# RO-4/RO-PURE

## 2012 CHANGES

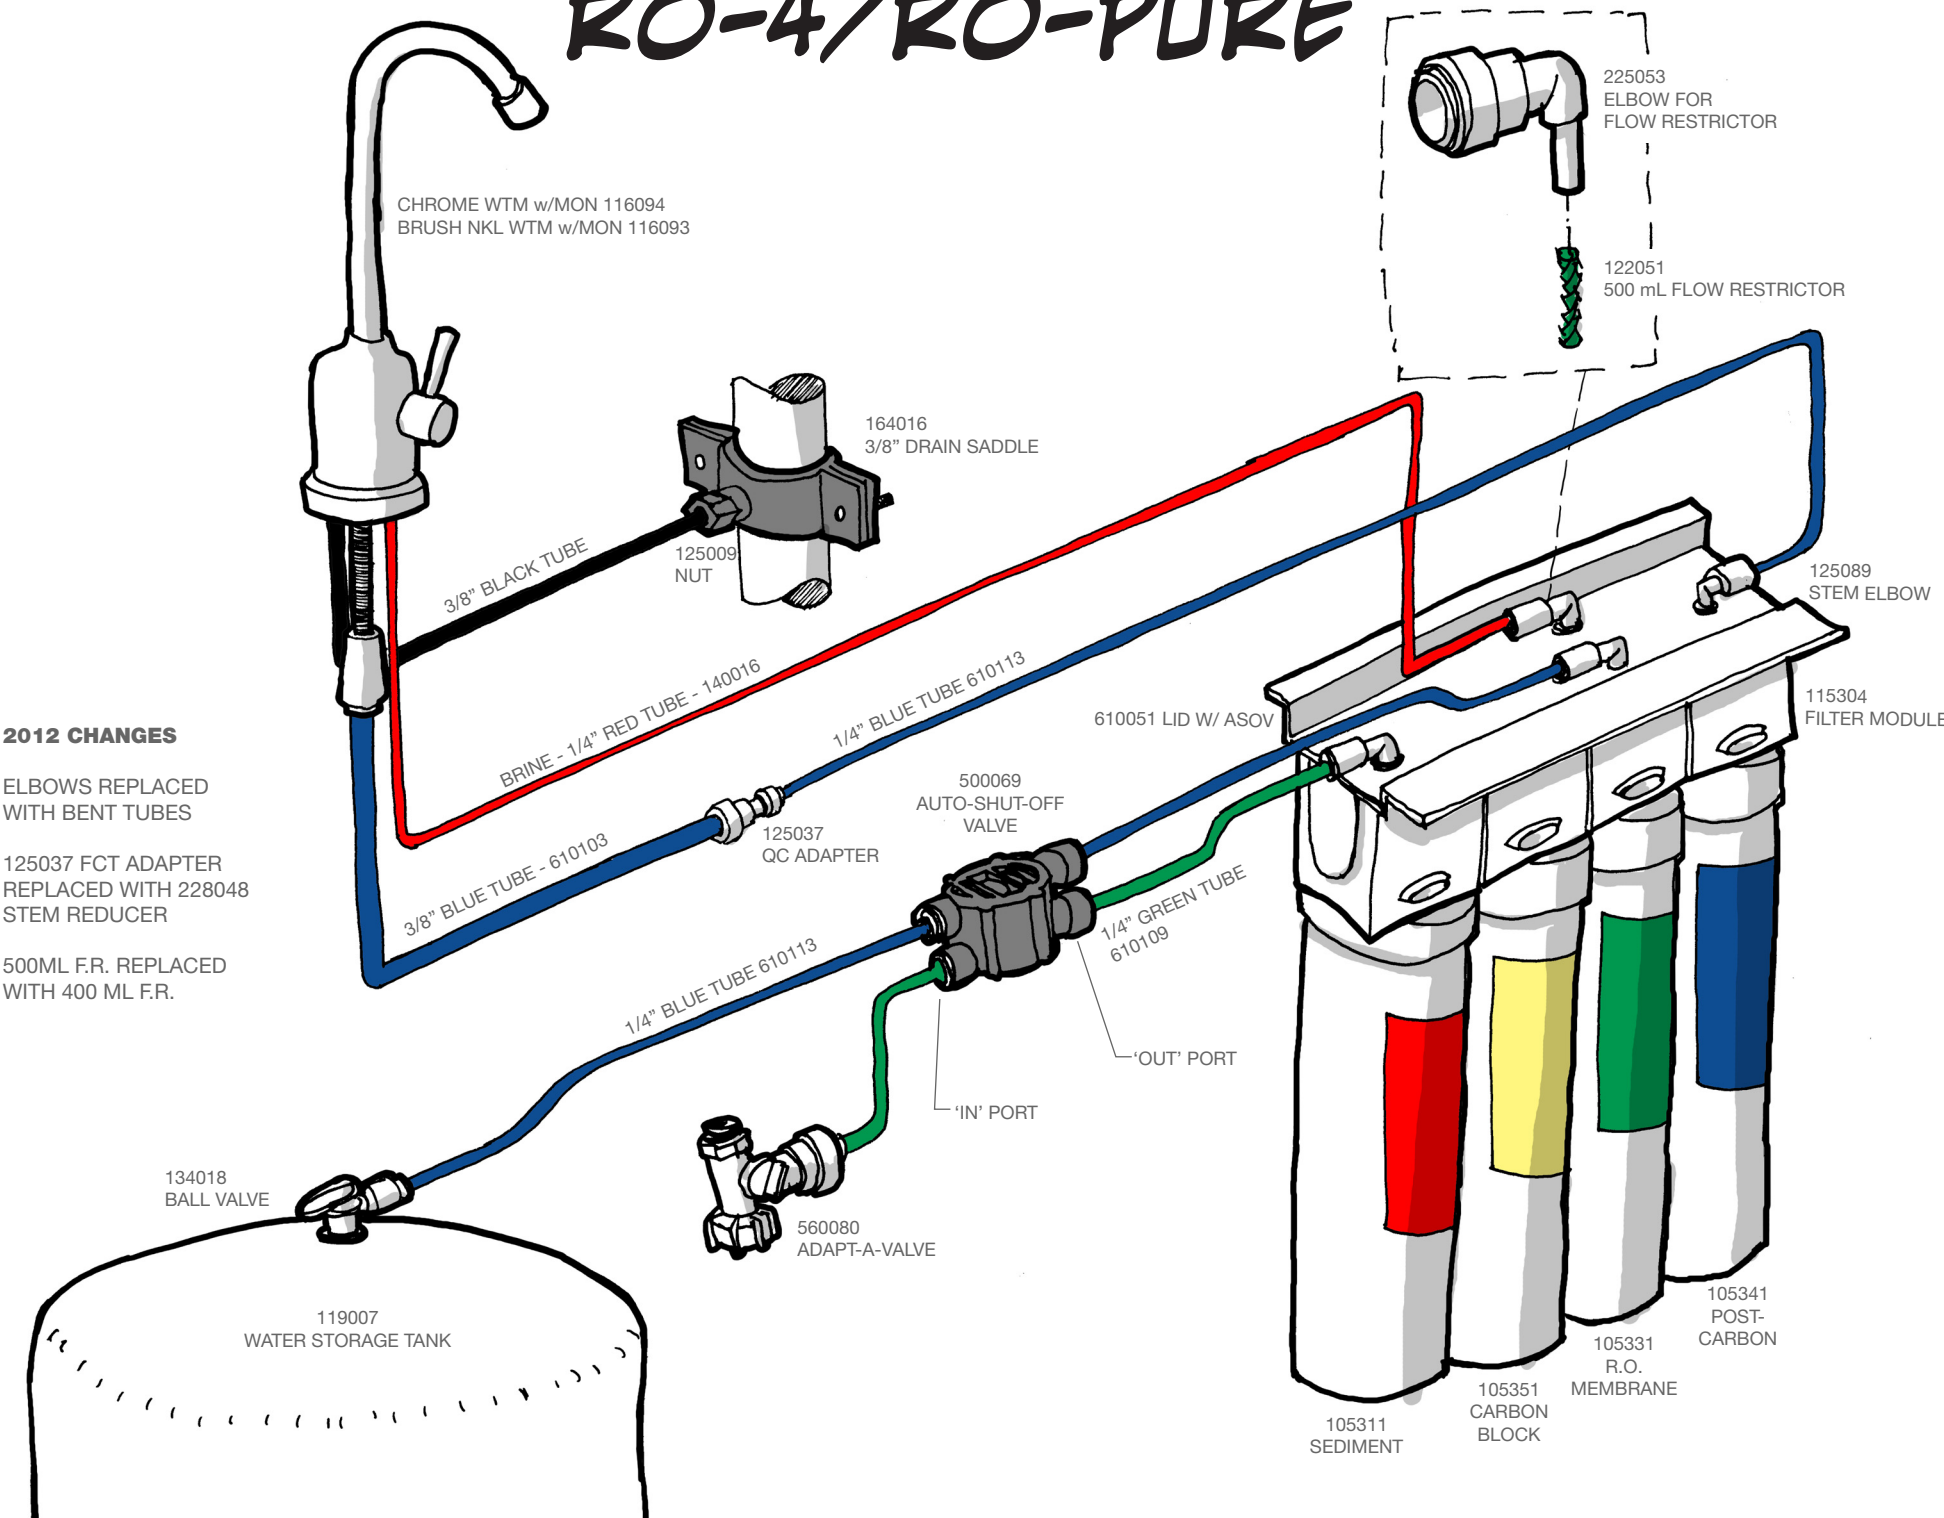
ELBOWS REPLACED WITH BENT TUBES

125037 FCT ADAPTER REPLACED WITH 228048 STEM REDUCER

500ML F.R. REPLACED WITH 400 ML F.R.
